NON-COMPLIANCE RECALL J050 [NHTSA# 15V-037]: OCS HANDBOOK DESCRIPTION INCORRECT - UPDATE

NO.: 7-096USA
(issue 2)

Publication Part No. JSA 18 02 34 151

E164858

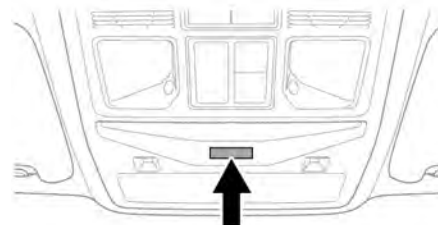
The system will adjust the passenger air bag status and operate the status indicator as follows:

Occupancy status	Passenger air bag status	Status indicator display
Completely empty	Deactivated	No indication given*
Child restraint or low weight occupant/object	Deactivated	PASSENGER AIRBAG OFF**
Heavy occupant/object	Activated	No indication given

* It is possible to receive an intermittent indicator illumination with an empty seat. This is part of the system's adaptive behavior and does not affect the status of the front passenger air bags. However, if the indicator becomes permanently illuminated when the seat is empty and the seat belt is unbuckled, contact your Dealer/Authorized Repairer immediately.

** In some cases, a small child placed in a child seat may not activate the deactivation indicator. If this occurs, the front passenger air bag status will be as described for an empty seat.
